ADDENDUM # 2
UC Merced Medical Education Building Project
Environmental Impact Report
State Clearinghouse Number 2021040047

Changes to the UC Merced Medical Education Building Project

October 2023

FIGURE 3-2

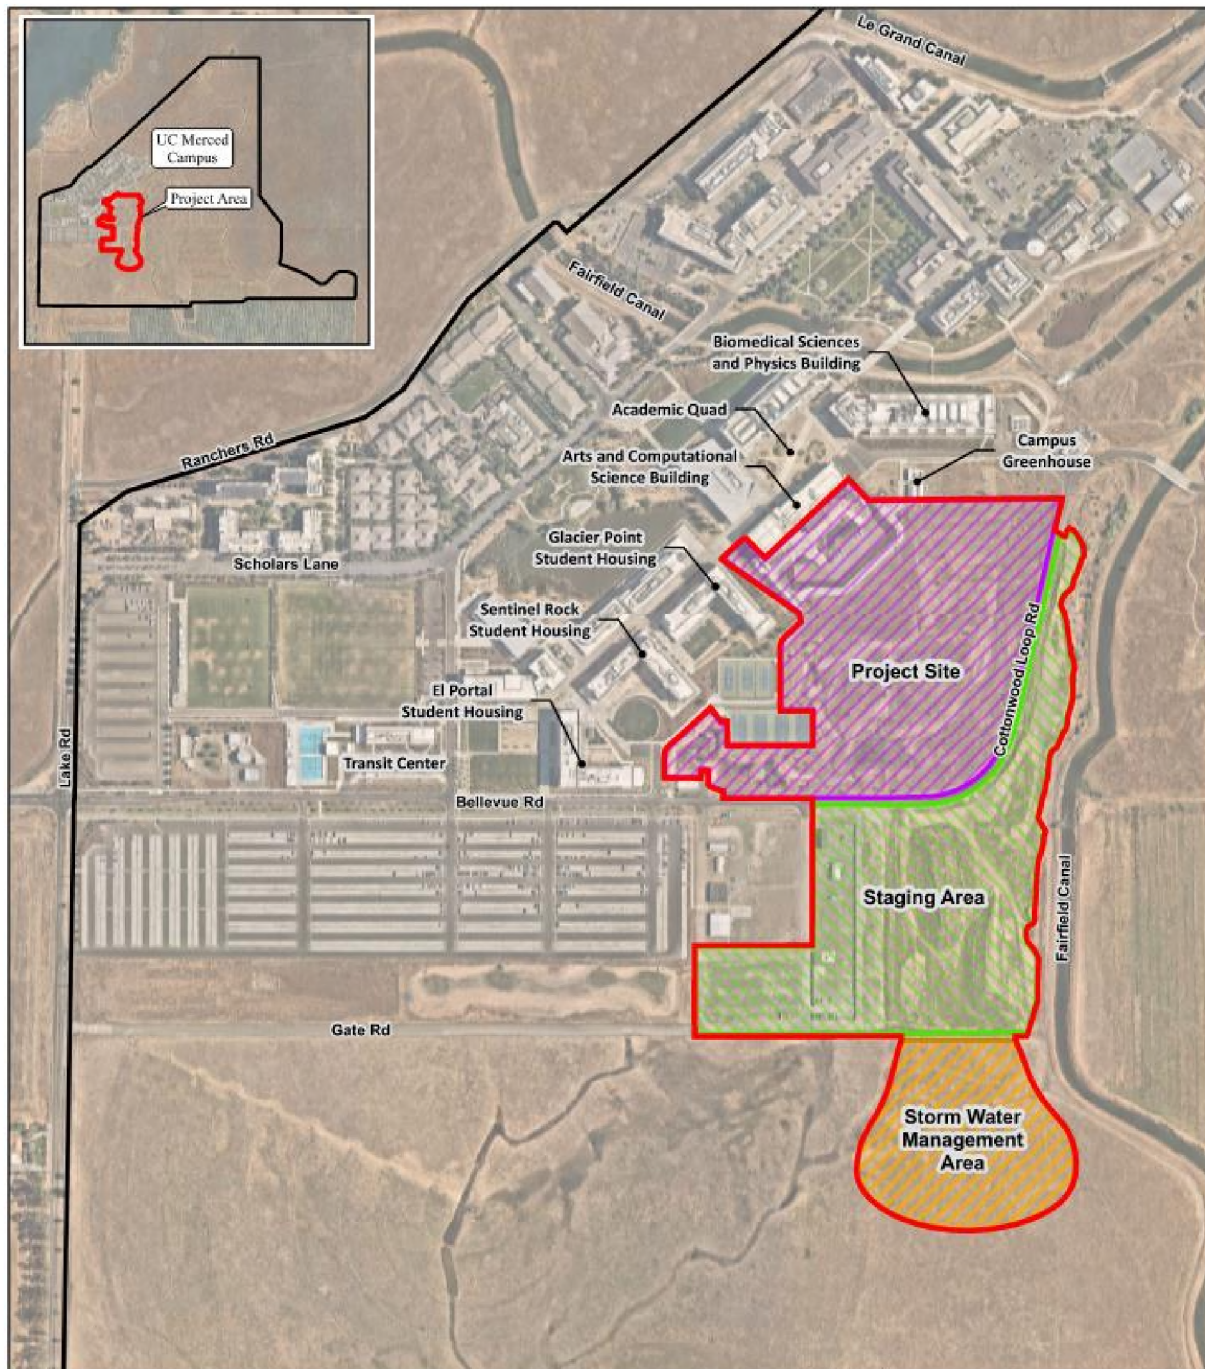
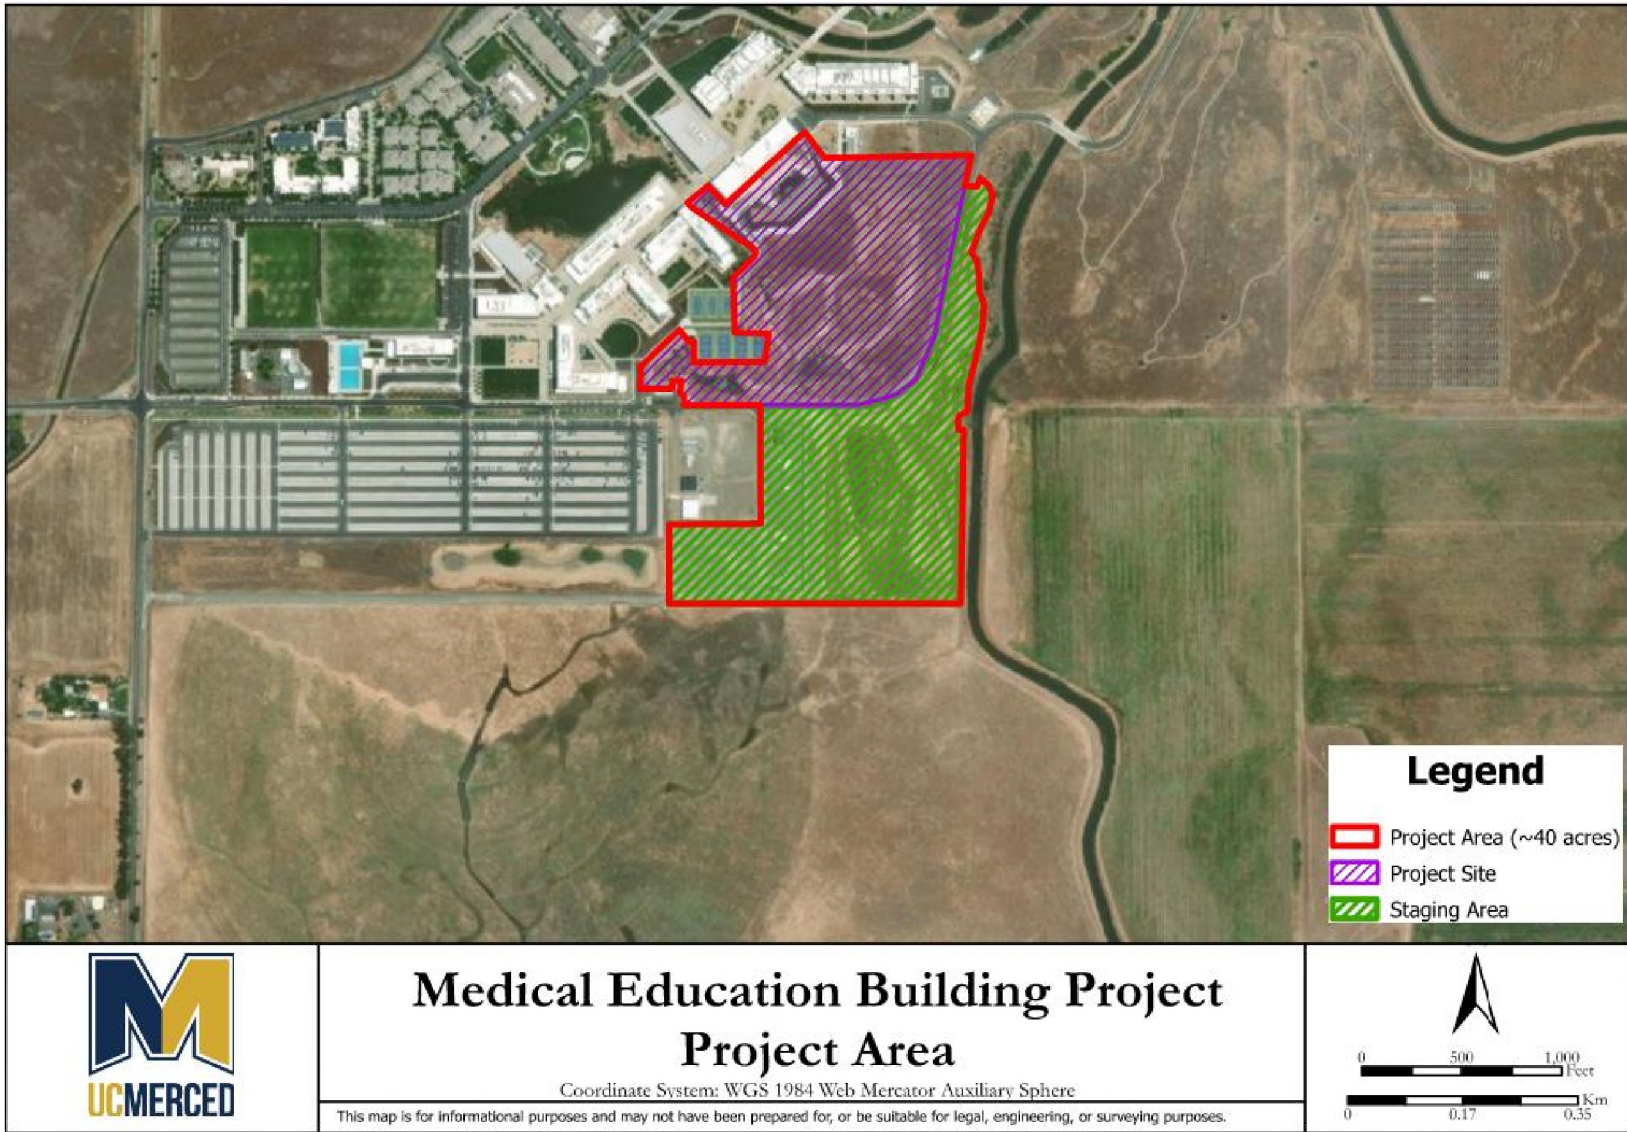
1. Removal of shade structure with cross-laminated timber wood panels with PV infrastructure to remain.
2. Shelling of the entire fourth floor to be finished at a future date.
3. Reduction in landscape to tighten up the building site.
4. Revised interior courtyard with landscape areas and pathways to accommodate Medical Education white coat ceremonies.
5. Rooftop penthouse wall – revised wall finish from glass fiber reinforced concrete to plaster wall finish.
6. Removal of the outdoor terraces on levels three and four.
7. Removal of double height space at main entry lobby.
8. Modification of existing storm water basins in Cottonwood Meadow to eliminate the need to construct anew storm water basin south of campus.

In conjunction with the revised building design, the site plan has been revised to reduce landscaping and tighten up the building site. As a result of these minor changes to the site plan, the total amount of impervious surfaces would be reduced from 4.4 acres to 3.7 acres, which includes the building footprint and hardscape areas. The previously analyzed 46.5-acre Project Area, comprising the building site, the area that would be used for construction staging, and the area where the proposed storm water detention basin would be located, will be reduced due to the elimination of the new 8-acre stormwater basin and modification of the existing stormwater basins within the project site to accommodate stormwater.

The revised stormwater basin plan would reduce the amount of disturbed area by approximately 8 acres. The EIR analyzed filling in and grading the stormwater basins located within Cottonwood Meadow and excavating a new stormwater basin. The project will now re-grade those areas within Cottonwood Meadow to accommodate the increased stormwater flows and the reduced stormwater containment created by the Medical Education building project. As a result, the current views of the area will remain similar to what exists today, and thus would not adversely affect public views of the campus from Lake Road.
